MEADOW GROVE SOUTH SECTION 8

**Re: Meadow Grove South, Sec. 8 / Franklin County  
Notice of Violation**

Meadow Grove South, Sec. 8  
Stabilize barren areas  
Install / maintain erosion controls  
Remove sediment from street  
Spoto River Watershed  
October 27, 2010  
Photo by: Greg Sanders

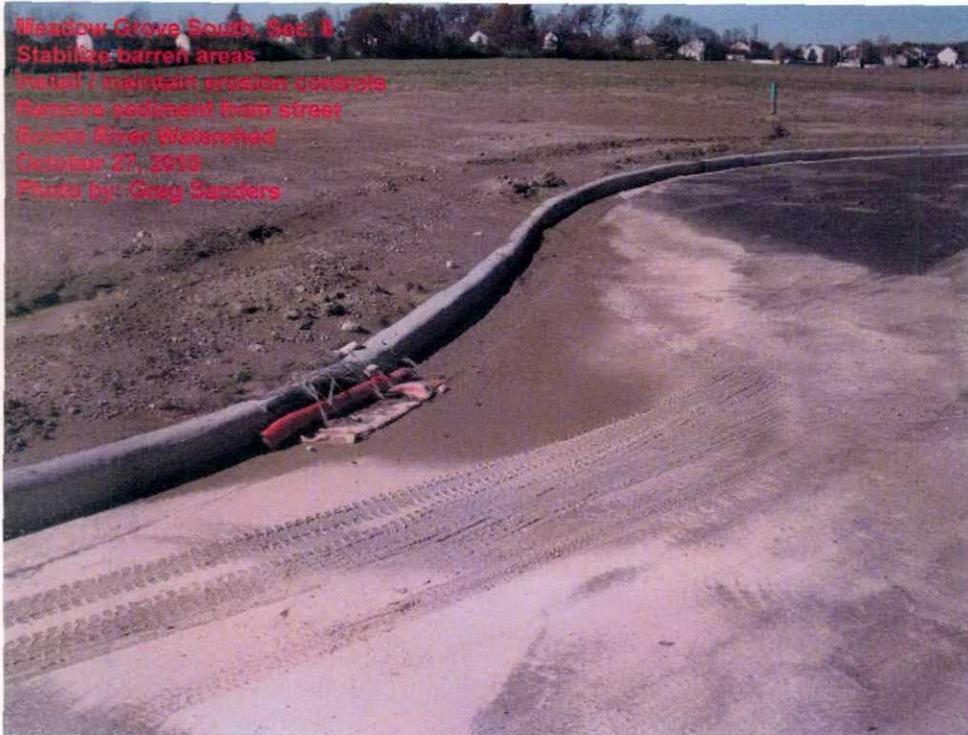
- The site lacked erosion controls except for a few dandy bags which needed maintenance. Sediment was eroding on to the road. Please install erosion controls immediately, such as straw waddles and silt fence. The erosion controls must be maintained and inspected weekly or after a significant rain event. A log of the inspections must be kept on-site. Please send me a copy of the log of inspections from the January 1, 2010, to the present. Please see attached pictures.

- Be aware the General Permit states that all barren areas including stockpiles which remain idle in excess of 21 days must be protected from erosion within seven days of the last earth disturbing activities. In addition, erosion protection must be implemented for all areas of final grade within seven (7) days. The site appeared to be near final grade. Given the time of year alternate erosion control measures such as erosion control matting, crimped mulching, mulch with netting and/or tackifier, or an approvable alternative must be implement for this site to ensure effective erosion control for the upcoming winter months.

- Please remove the sediment from the road.
